**Louisville - Southern Indiana Ohio River Bridges Project
Indiana and Kentucky Historic Preservation Advisory Team
Meeting – November 27, 2007
TARC Administration Building**

East End Bridge Presentation: Miguel Rosales, SDC5

The following shows the average ratings that were provided.

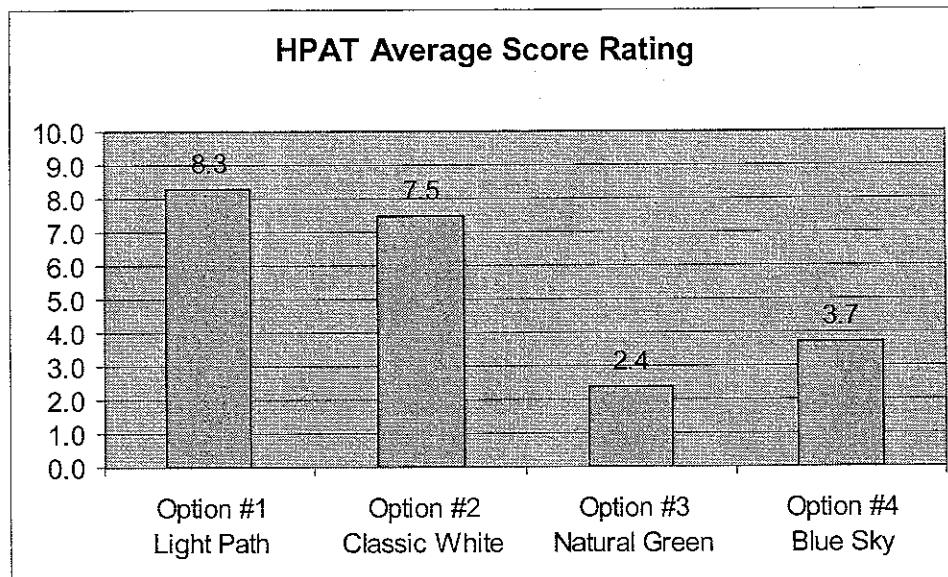
- The comment forms received from the HPAT members indicated an overall preference for Option #1 Light Path, followed closely by Option #2 Classic White.
- The comments indicated that Option #1 Light Path was the most minimal of the concepts, which is desirable in the context of the bridge site. Others indicated that Option #2 Classic White was preferred. Some comments suggested that lighting of the cables, even minimally, emphasized this important part of the design.
- Several HPAT members indicated a preference for the railing lights for the walkway, in order to minimize the spill of light off of the bridge.
- Others indicated that the underneath side of the walkway should not be lit, in order to maintain as much darkness in the area as possible.
